Subject: Duke Power Company LLC d.b.a. Duke Energy Carolinas,  
LLC

McGuire Nuclear Station, Units 1 and 2  
Docket Nos. 50-369 and 50-370

License Amendment Request Revising McGuire Units 1 and  
2 Updated Final Safety Analysis Report Commitments to  
USNRC Regulatory Guide 1.82, Revision 0, "Sumps For  
Emergency Core Cooling and Containment Spray Systems"  
and Revising McGuire Units 1 and 2 Technical  
Specification Surveillance Requirement (SR) 3.5.2.8  
and Associated Bases

Figure 1  
 Original ECCS Sump Strainer  
 (UFSAR Figure 6-196)

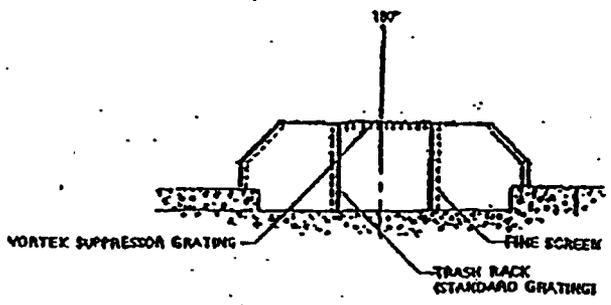
The as-built configuration of the McGuire Unit 1 ECCS containment sump structure (and original Unit 2 ECCS containment sump structure) is illustrated by McGuire UFSAR Figure 6-196 (see Figure 1 of Attachment 4). For each Unit, the ECCS containment sump structure consists of stainless steel framing that provides the structure for attachment of a stainless steel fine mesh inner screen and an outer trash rack grating. A solid top deck is provided.

The train-specific suction pipes exit lower containment through horizontal penetrations incorporating guard pipes. Each open-ended sump suction inlet line originates in the interior of its train-specific strainer enclosure (see Figure 1). The net screen surface area provided by both ECCS trains is approximately 135 square feet, or 67.5 square feet per train.

Figure 3A

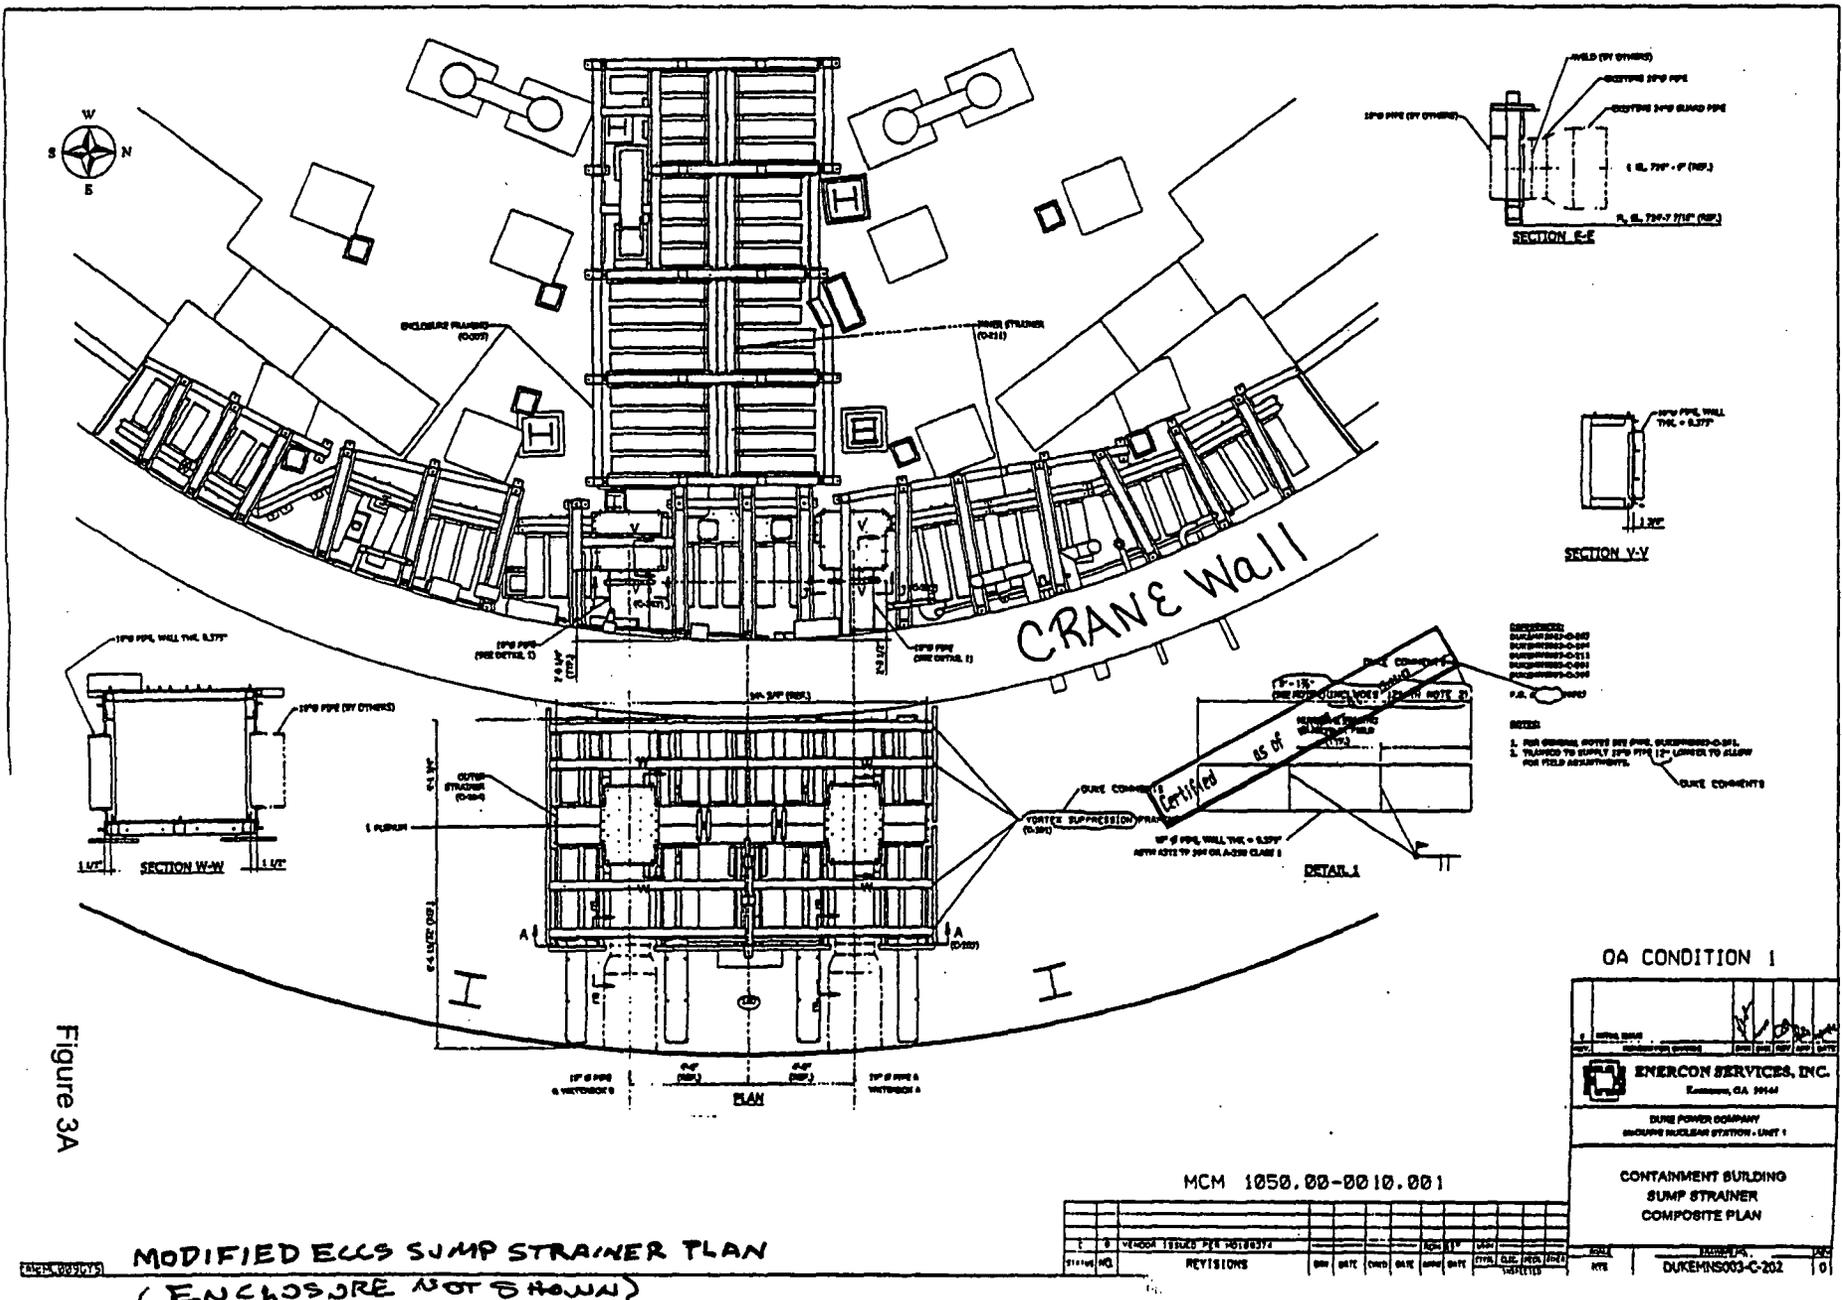
The McGuire strainer modification removes the original ECCS containment sump structure described above and replaces it with a complex strainer assembly located inside and outside the crane wall (see Figures 2, 3A and 3B of Attachment 4). The plenums and strainer portions located Inside the Crane Wall (ICW) are housed within a stainless steel enclosure that preserves the original 'remote sump' design.

Simplified RHR and CS System Flow Diagram

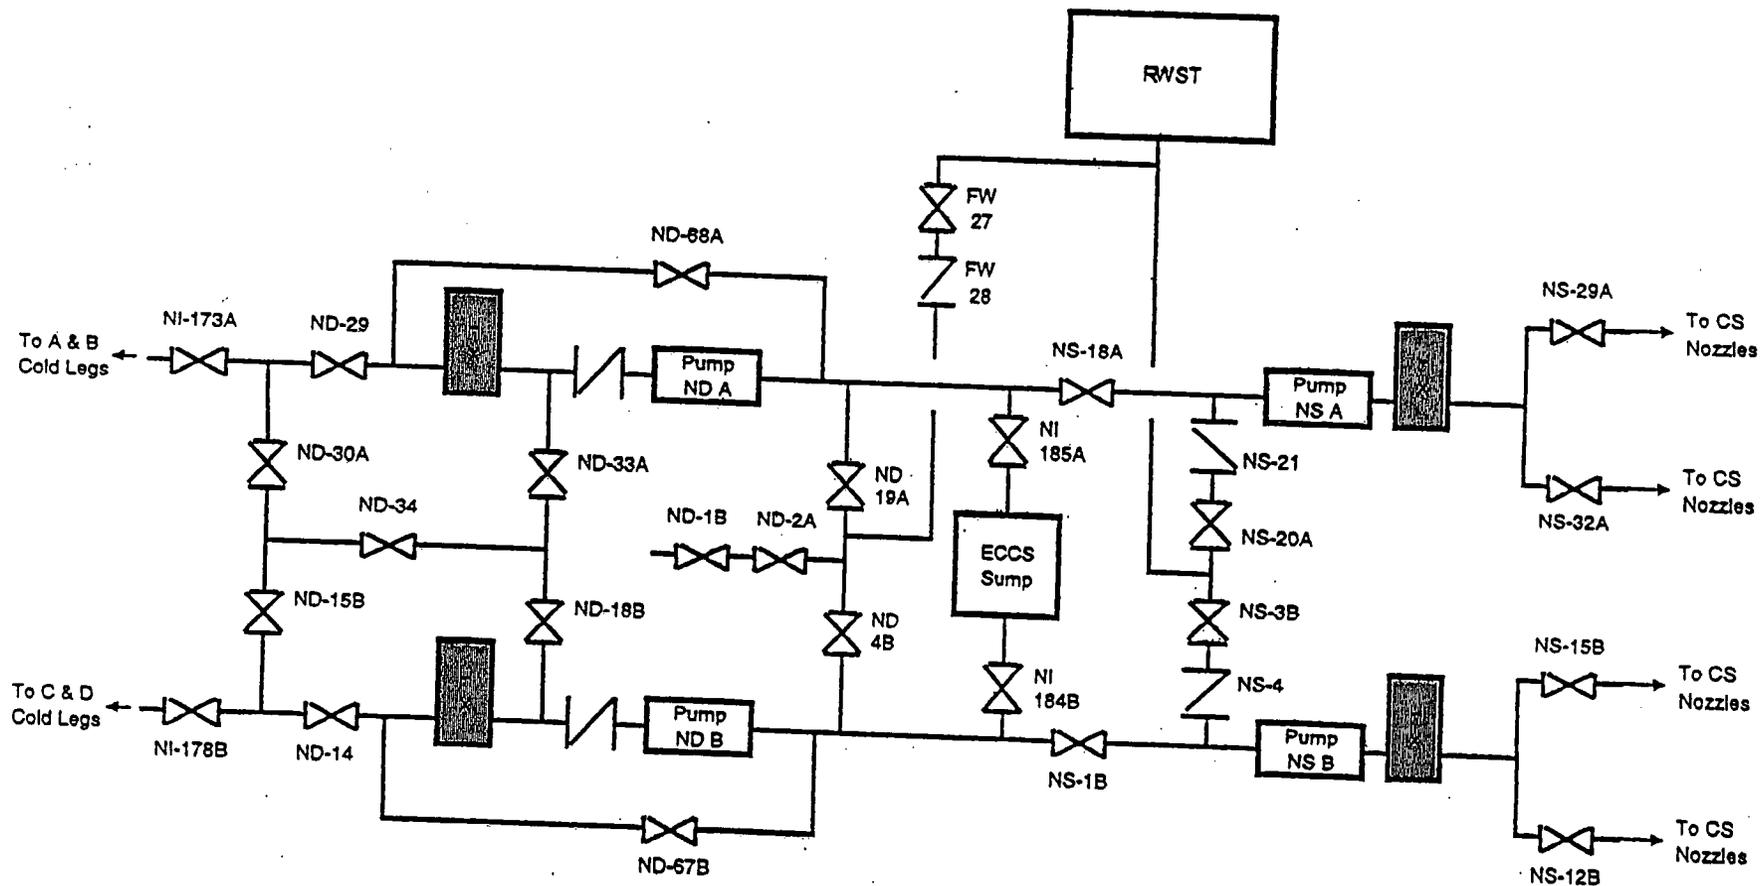
As shown by Figure 7 of Attachment 4, pump discharge check valves and limited recirculation flow paths present significant obstacles to a backflushing strategy. To achieve even minor backflush flow would require operation of several active components for which no redundancy is available, and therefore, no such plan is credited or proceduralized.
